20210913-ABP-308019

ABP Ref.: 308019
App: Gort Windfarms Limited
For: Derrybrien Windfarm Substitute Consent
Site: Coppanagh, Slieveanore, Loughatorick North, Boleyneendorrish, Kilbeg, Toormacnevin, Funshadaun, Derrybrien North, Derrybrien South, Bohaboy, Derrybrien West, Derrybrien East, Derreenamucka, County Galway

An Taisce wishes to make the following submission on the above Substitute Consent application without prejudice to the fact that it was not properly notified to An Taisce.

Figure 1: Contents of Appendices as listed in the Chapter 10 Main Chapter

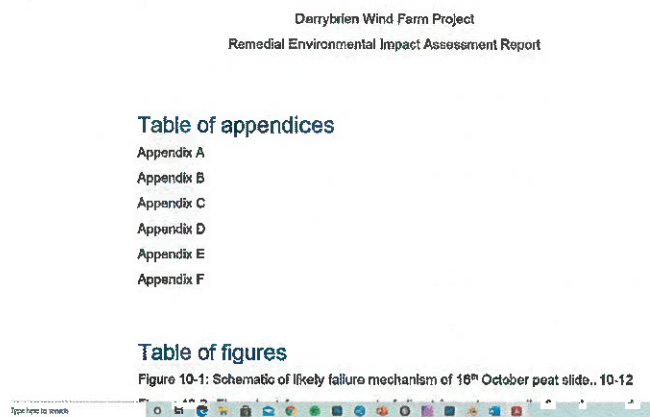
The rEIAS document provides a list of contents for the document itself, but provides no information in the Contents pages about what is contained within the Appendices (see attached Figure).

This provided list of Appendices suggests that there are six Appendices, A – F, but what these contain and what their significance might be is left to the reader to guess. Turning to the Appendix document itself (namely Chapter 10 – Soils, Geology and Land Appendices, Document No.: QS-000280-01-R460-001-000), this provides no Contents page or Index at all, other than the contents pages of the individual reports presented within the appendices – to which there is no guide at the start of the document. Furthermore, it emerges that there are not six Appendices but instead a nested multitude of Appendices, in some cases going down as far as four levels of Appendix.

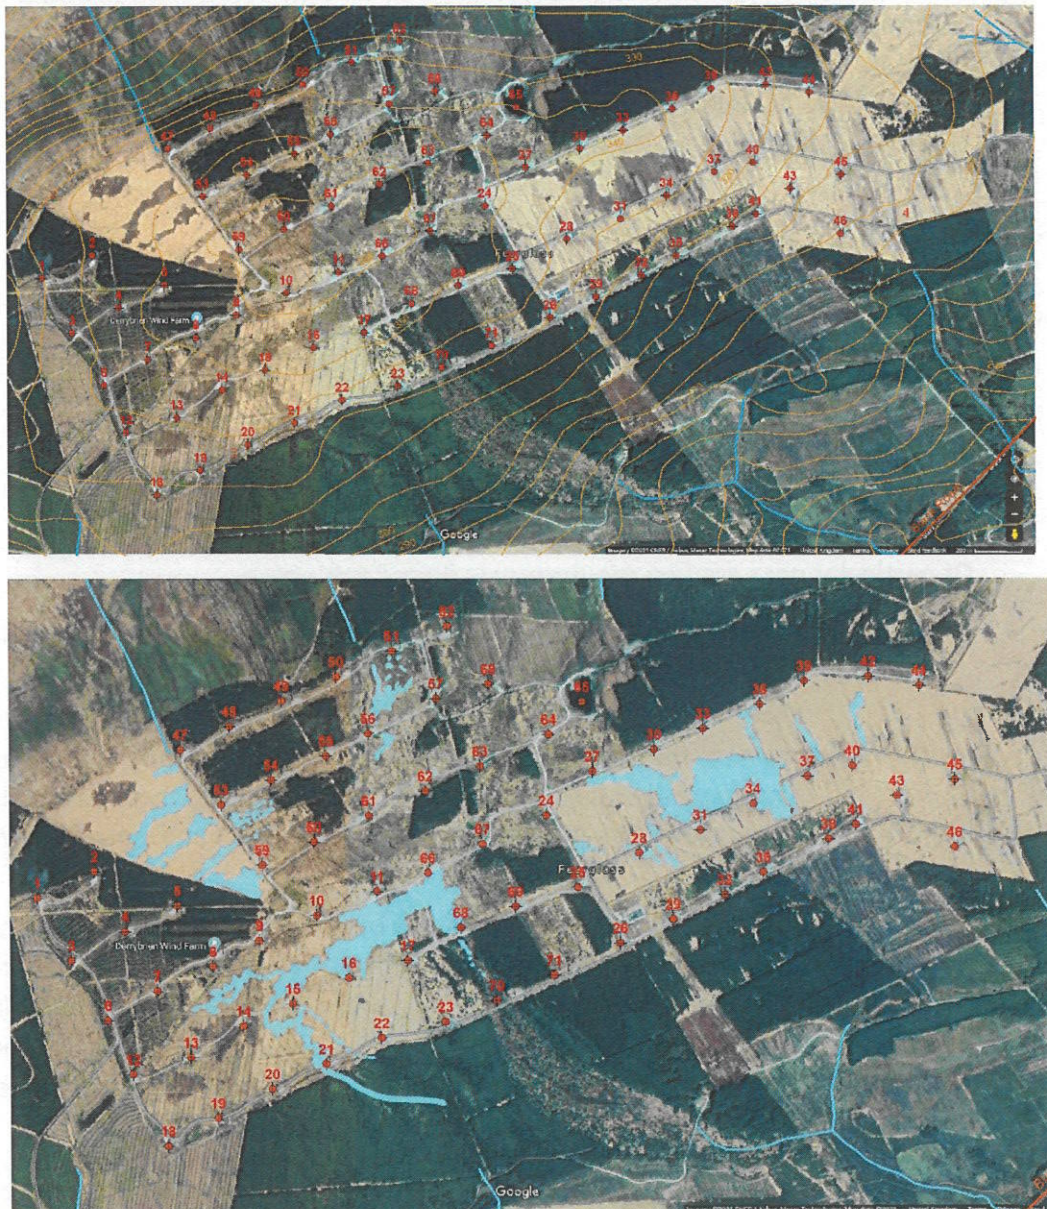
It seems likely that there is further failure in basic mapping of the ground condition in terms of how the information obtainable from aerial photography has been interpreted. With reference to the aerial photographs provided as ‘*Figure 10-4 in Section 10.2.1.3*’ of the rEIAS and ‘*Figure 2-1 of Appendix E*’, the latter figure points to a dark sinuous band of colour crossing the turbary area and describes it as ‘*deep peat along subsurface drainage channel*’ which is undoubtedly the case, given the sinuous nature of the dark shading.

A similar band of sinuous shading which forms a huge crescentic shape leading down into the same ‘shallow valley’ which experienced the 2003 peatslide (see Figure 2) is merely identified (along with others) as an ‘*Area of deeper peat and high water table on flat terraces (Darker vegetation)*’ but with no mention of the (very likely) possibility that this, too, is an area of sub-surface piping and/or seepage. Furthermore, the dark zones identified in the NW corner of the aerial photograph and lying just outside the windfarm boundary actually point downslope and converge on a natural drainage line, so it is possible that these, too, are seepage zones or areas of sub-surface piping.

Further areas of dark ground can just be discerned vanishing into the forest blocks within the windfarm site, so it is possible that sub-surface seepage is widespread within the site. These may be natural zones of seepage, but published evidence from, for example, Holden *et al.* (2002) and Holden (2005) have identified a clear linkage between drying peatlands and prevalence of sub-surface piping.

It should also be noted that the heads of the pale blue seepage zones in Figure 2 all begin along the line from Turbines 27 to Turbine 42.

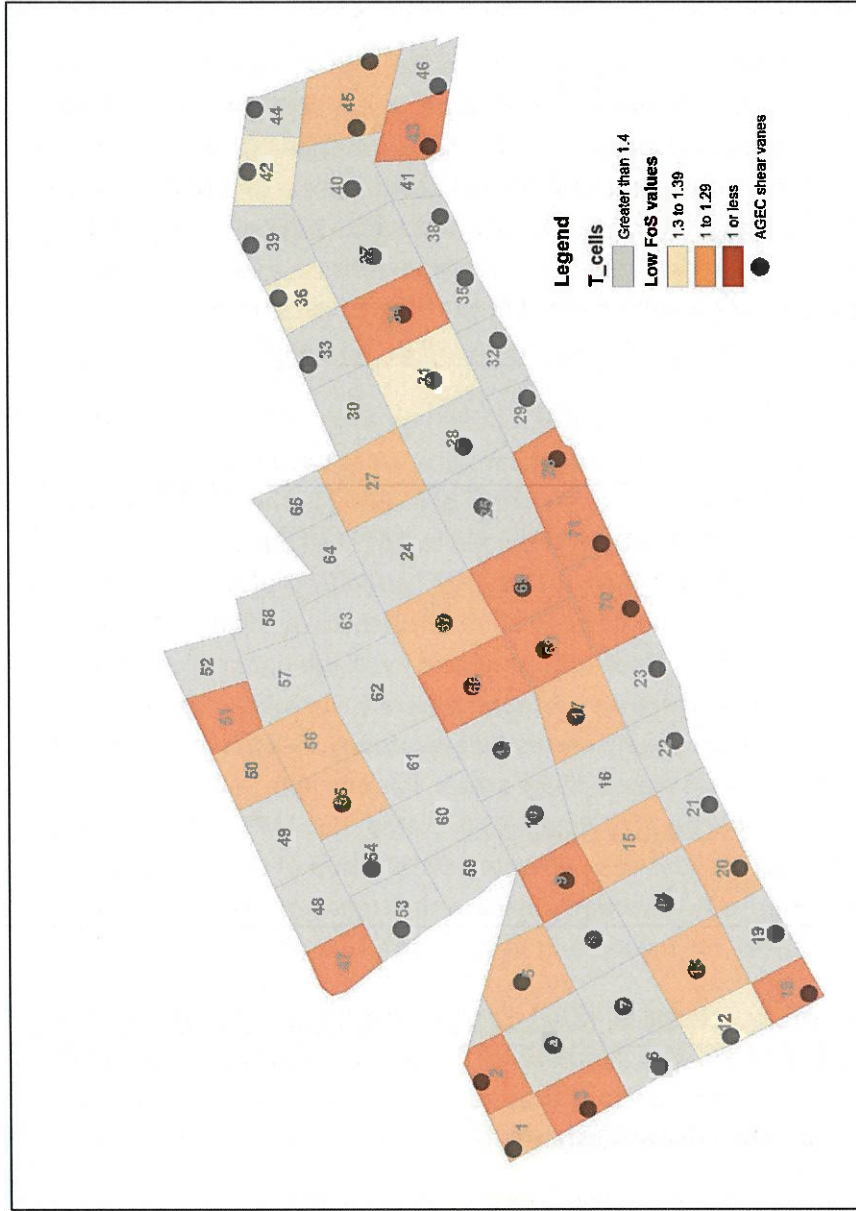
Secondly, the FoS calculation for each T-cell was based on testing the peat in only a single location in each T-cell, and even this in only a proportion of the full set of T-cells (see Figure 6).

There is little indication that the AGECE (2004) findings, albeit from what is described as an ‘unrealistic hypothetical’ case, were used to guide further consideration of risk. The risk assessment presented in the rEIAS is instead based on the much larger dataset provided by ESBI (2005) and now presented in ‘Appendix XIV (Vols. 1 and 2) of Appendix D of Appendix B’. This represents the only additional site-wide data currently available. There has been no extensive survey since that time, and even the data collected in 2004 and 2005 cannot be described as comprehensively site-wide. Significant areas of the site remain largely un-tested even today, despite indications that critical factors may be at play in these areas. For example, although ‘Appendix XIV of Appendix D of Appendix B’ states that 1179 shear vane tests were carried out across the site, when the distribution of these tests is examined (see Figure 7) it becomes evident that many of AGECE’s T-cells still either have no shear vane sample or at most only one or two.

The risk assessment offered in ‘rEIAS, Section 10.2.4.4 and Figures 10-34, 10-35, 10-36’ is thus based on a synthesis of the data gathered some 16 years ago in 2004/5 across only parts of the site and is essentially a re-working of this information into a risk assessment.

Figure 8. Peat Stability Assessment by AGL (2020) for baseline conditions in 1998 for each T-cell. Highest risk rating is '5'. Note the concentration of high risk cells in the northern section of the site, and also the high risk value along the western margin of the site.

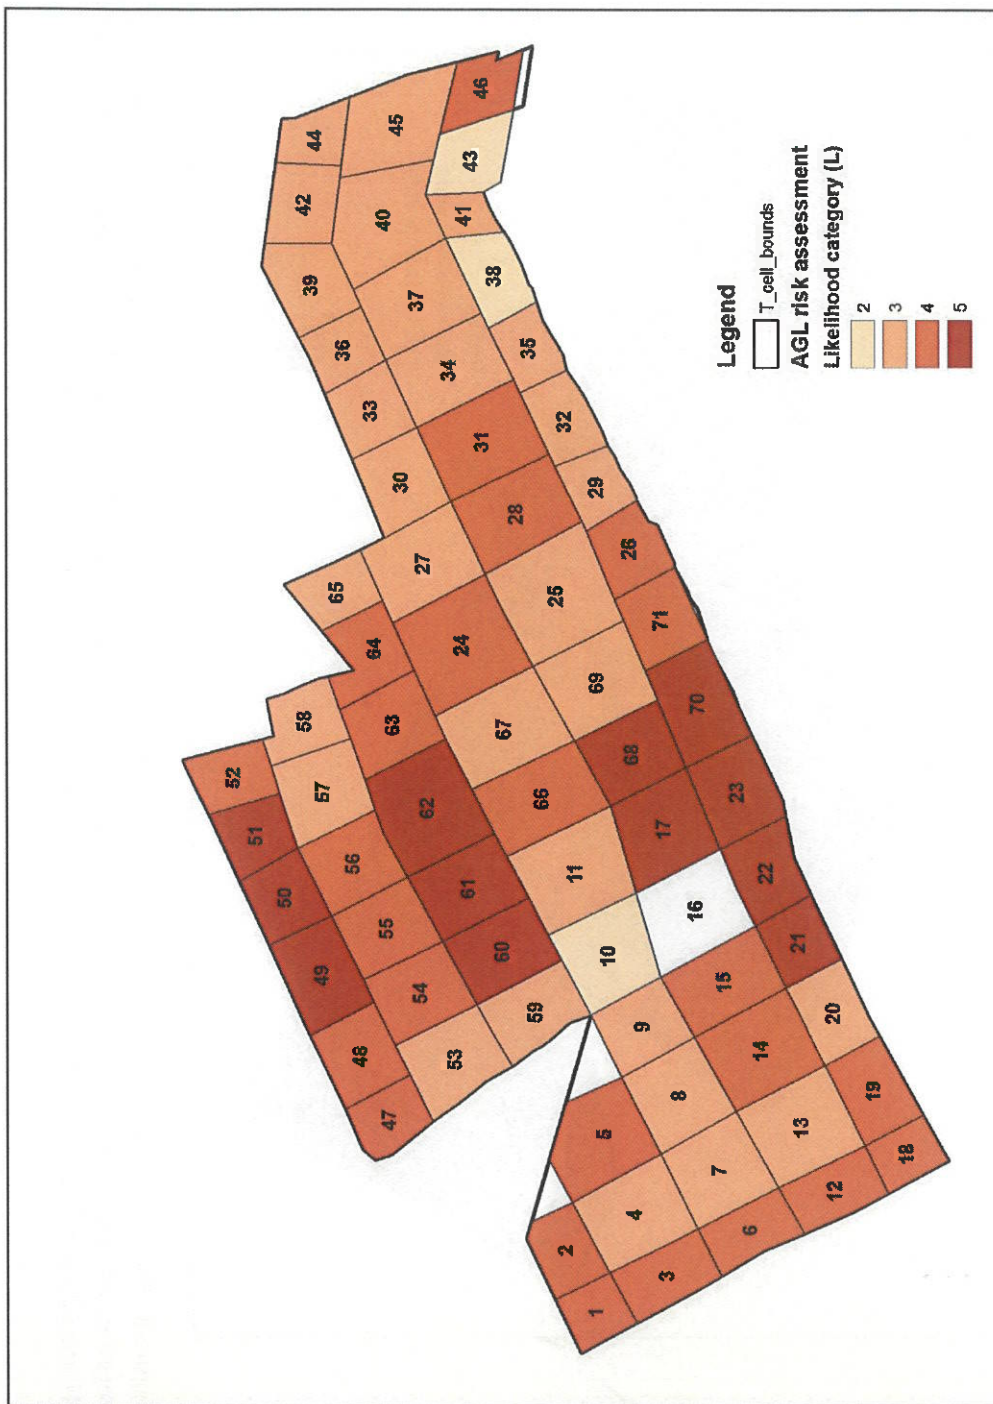
significant risk of instability and consequent impact (see Figure 8). The distribution of shear vane tests in relation to this assessment can be seen in Figure 9, while correspondence with the original ‘worst-case’ map generated by AGECE (2004) can be seen in Figure 10.

What is most striking about the areas identified as being at risk in by AGECE (2020) is the clear concentration of T-cells at risk in the northern sector of the site, mirroring the already-failed area of the 2003 slide to the south. This region remained largely un-surveyed by AGECE (2004) so the main records for peat condition come from ESBI (2005). Even after this survey, however, some critical T-cells remain largely un-tested, as can be seen from Figure 9. They still emerge as being significantly at risk because of other risk factors. Concentration of high-risk areas in the northern and western parts of the site is reinforced by the findings of the AGECE (2004) report, as can be seen in Figure 10.

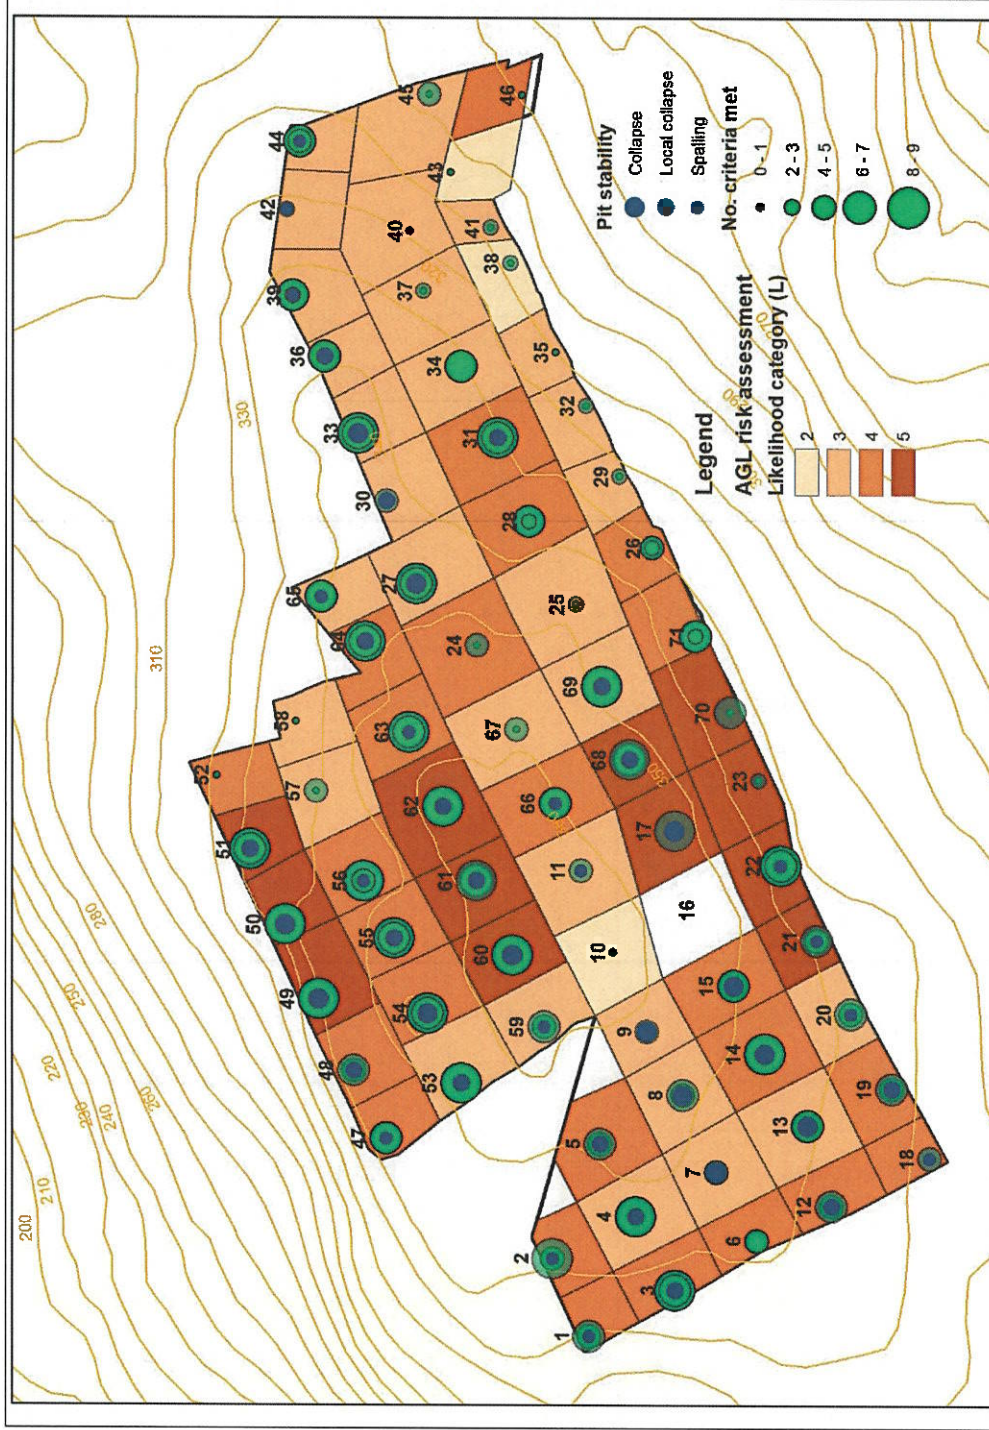
Figure 11 compares the distribution of T-cells at risk based on the data in Table 3 with the distribution of at-risk T-cells presented by the rEIAS (and shown in Figure 8 above). From this it can be seen that there is good correspondence across all those T-cells identified in the rEIAS, but the revised assessment based on the data in Table 3 highlights a number of additional T-cells.
